APPLICATION NO.	FILING DATE	FIRST NAMED INVENTOR	ATTORNEY DOCKET NO.	CONFIRMATION NO.
10/779,661	02/18/2004	Fumitomo Matsuoka	249040US-2S DIV	1341
22850	7590	02/24/2006	EXAMINER	
OBLON, SPIVAK, MCCLELLAND, MAIER & NEUSTADT, P.C. 1940 DUKE STREET ALEXANDRIA, VA 22314			LEE, EUGENE	
			ART UNIT	PAPER NUMBER
			2815

Office Action Summary	Application No. 10/779,661	Applicant(s) MATSUOKA, FUMITOMO	
	Examiner Eugene Lee	Art Unit 2815

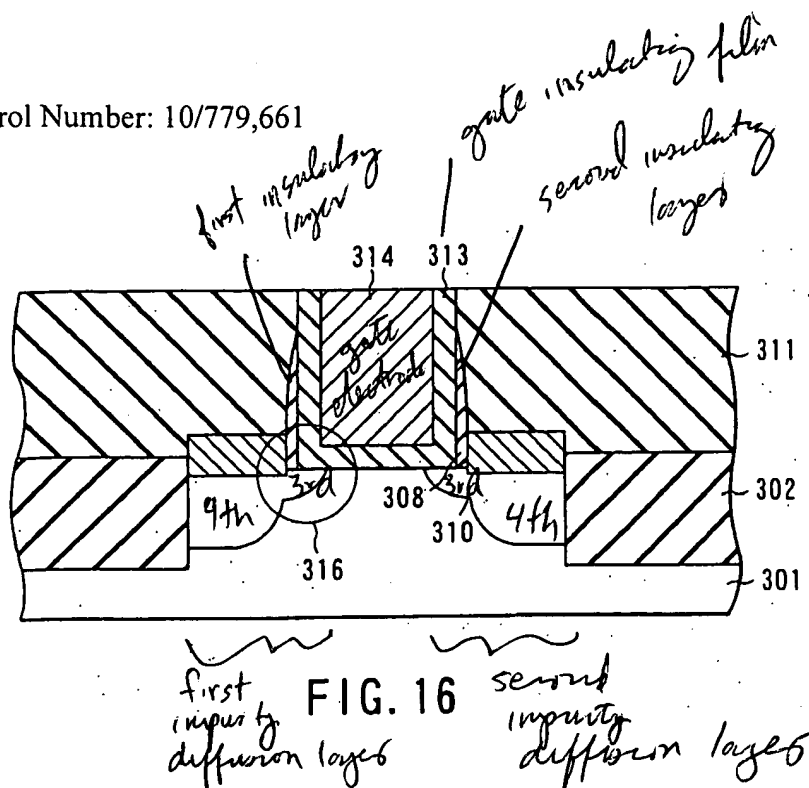
In claim 17, it is unclear what the applicant construes as the third impurity diffusion layer, and the fourth impurity diffusion layer since the fourth impurity region appears not to be beneath the second insulating layer 308 as stated in the claim. The fourth impurity diffusion layer is at a lower level than the any of the first insulating layer and second insulating layer 308,

however, it is unclear whether this “lower level” constitutes “beneath” as disclosed in the applicant’s claim since it is not directly underneath the any of the first insulating layer and second insulating layer. Appropriate clarification and/or correction is required.

Regarding claim 18, it is unclear how the metal silicide layer is beneath the first insulating layer and the second insulating layer. In FIG. 16, it appears the metal silicide layer 310 is adjacent rather than beneath the metal silicide layer even though the metal silicide layer is at a lower level than the first insulating layer and the second insulating layer. It is unclear whether the applicant interprets this lower level as “beneath” as disclosed in the claims. Appropriate clarification and/or correction are required.

In view of these 112 rejections, the figure below shows how the Examiner interprets the applicant's claims in relation to the applicant's FIG. 16. For the sake of clarity, it would like to be confirmed whether this is how the claims limitations were intended to be read, however, it is not required.
